CONDON WIND PROJECT

Final Environmental Impact Statement
DOE/EIS-0321

Bonneville Power Administration has completed the Final Environmental Impact Statement (EIS) for the Condon Wind Project. This abbreviated Final EIS is made up of three parts:

Changes to the Draft EIS that, combined with the Draft EIS, constitute the Final EIS for the Condon Wind Project.....	29
--	-----------

Figure 2.1-3
Turbine Features, 600-KW

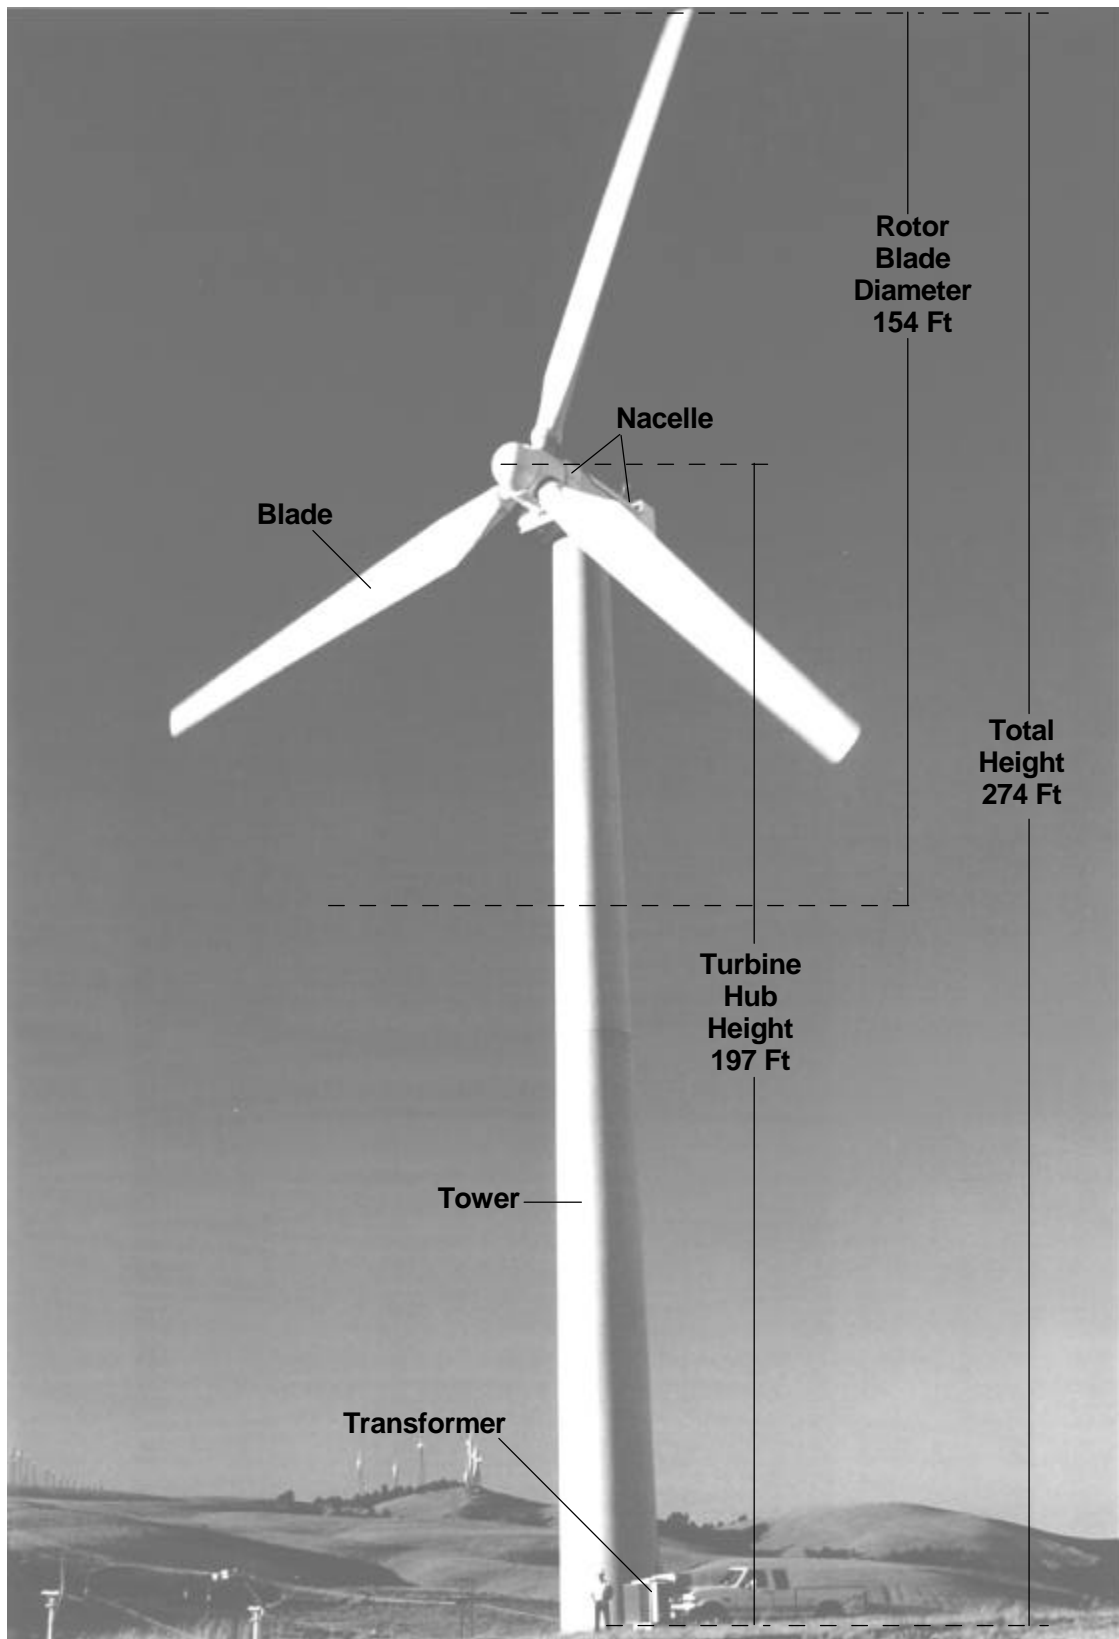
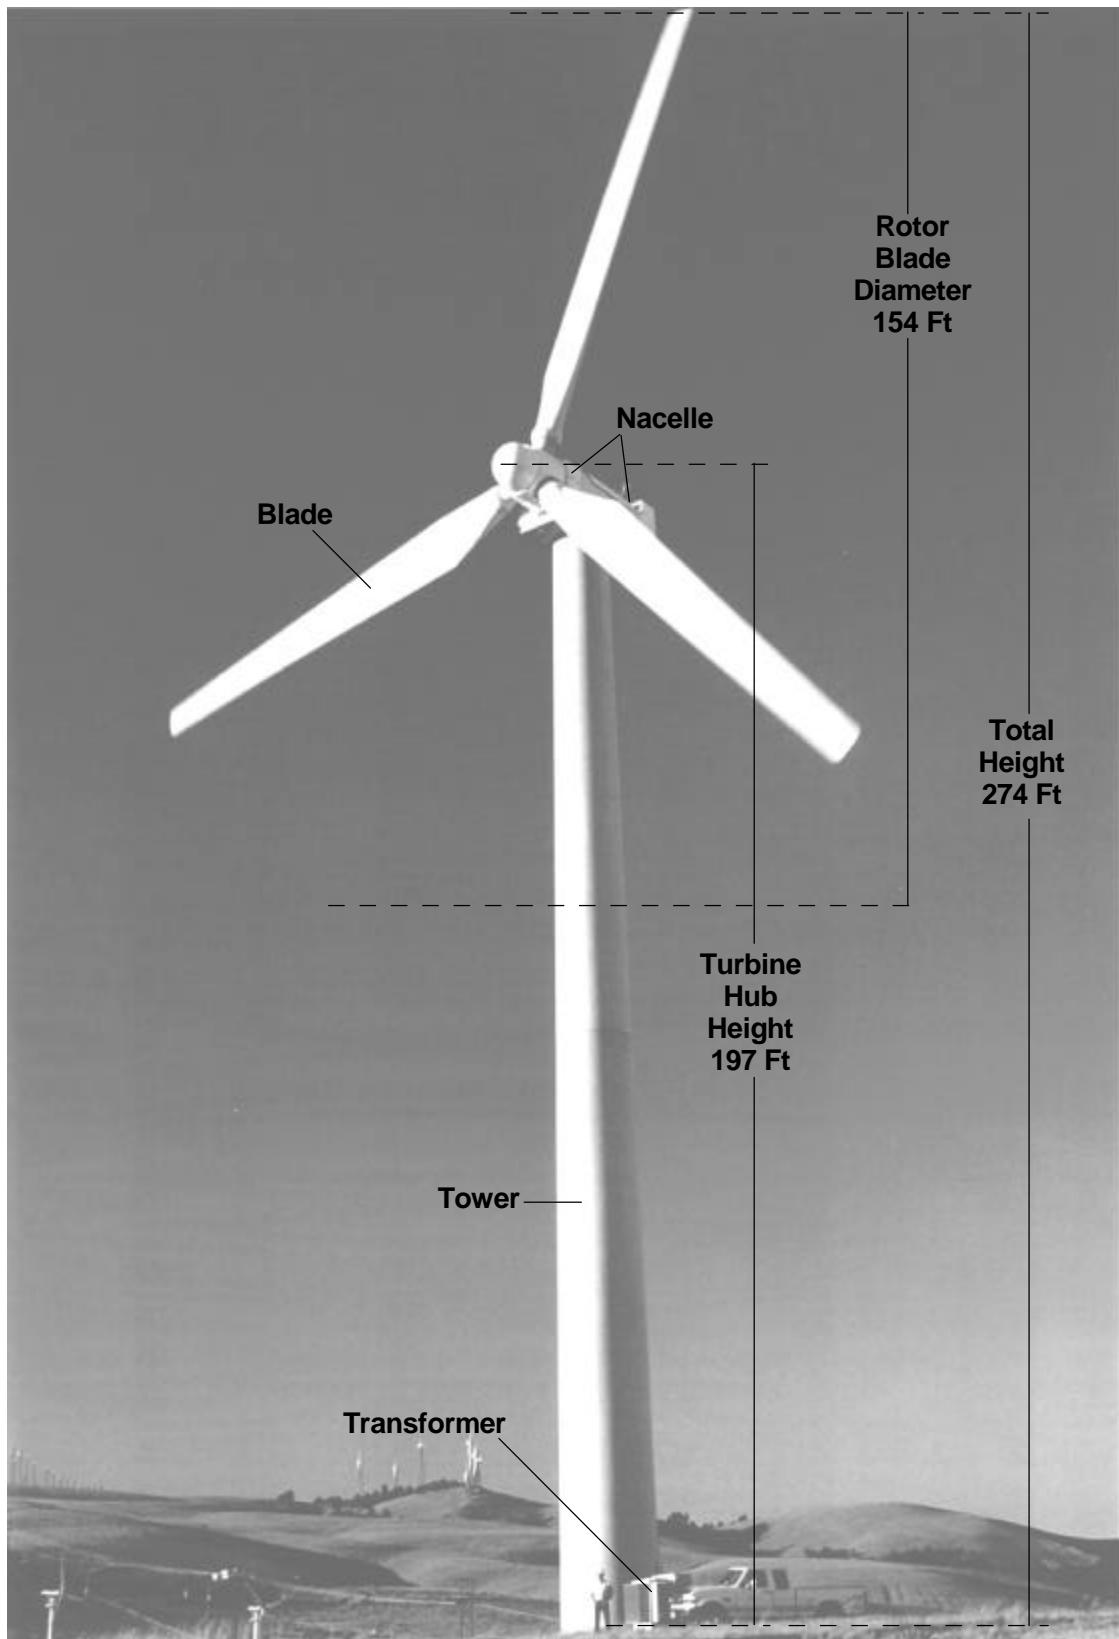
[AMEND DEIS] Figure 2.1-3—Turbine Features, 600 kW, replace with figure that follows this page.
